Subject: Comments on Seattle Tacoma International Airport Project
Third Runway – Embankment Fill and West MSE Wall, and
Industrial Wastewater System Lagoon #3 Expansion Project
On Second Public Notice

Applicant: Port of Seattle
Reference: 1996-4-02325

GeoSyntec Consultants (GeoSyntec) has been retained on behalf of the Airport Communities Coalition to provide a technical review of investigation, analysis and design relating to construction of the embankment fill and West Mechanically Stabilized Earth (MSE) Wall elements of the proposed Third Runway Expansion Project at the Seattle Tacoma International Airport. This letter summarizes GeoSyntec's comments on these items. Additional comments are included in this letter regarding the proposed expansion of the Industrial Wastewater System Lagoon #3. Our technical review included the documents listed in Attachment A to this letter.

Figure 1: Hypothetical Seismic Stability Failure Surface

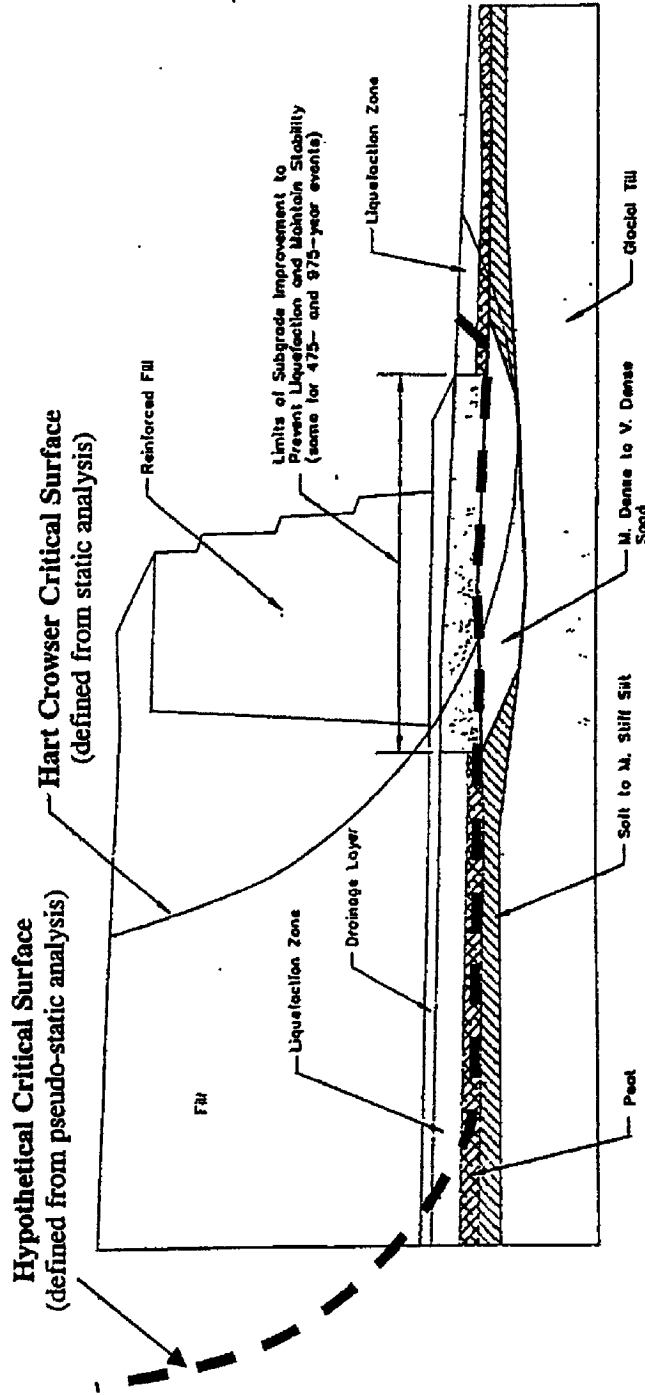
Comment 7: The methodology used in performing pseudo-static (seismic) stability analysis is incorrect and may seriously underestimate the ability of the wall to withstand seismic loads.

According to Hart Crowser, "We typically apply the seismic coefficient to the most critical failure surface identified in the steady-state condition." No justification is given for using this methodology, and it is in fact incorrect as the critical static (steady-state) and seismic failure surfaces are frequently very different. Under pseudo-static conditions, a horizontal acceleration is applied to the entire failure mass, which acts as a destabilizing force. The computed critical failure surfaces for the seismic case tend to be longer, extending further back into the slope in order to collect more driving mass. The critical surface for the seismic case will also frequently extend along a weak material interface, such as the existing peat layer, or through the liquefied sand deposit.

A proper pseudo-static slope stability analysis should be performed to search for the critical failure surface independently of the static analysis. Additionally, "sliding block" failure surfaces that propagate along the weak seams should be examined, rather

than just circular surfaces that cut across them. The Slope/W_ program that Hart Crowser is using is well suited to explore these alternate failure surfaces, and to search carefully for an independent critical pseudo-static failure surface. This analysis will likely result in a reduced factor of safety and may lead to requirements for additional ground improvement.

Figure 1 shows a conceptual sketch of a representative failure surface under pseudo-static conditions, extending through the weak peat layer far back into the fill (and potentially beyond the limits of the modeled cross-section). As currently analyzed and designed only the weak soils directly below the wall are being improved. If the critical seismic failure surface extends along the weak peat layer or liquefied zone farther back into the embankment than the static surface, the areas for ground improvement will also need to extend further back in order to remove the threat of these weak soils under a strong earthquake.
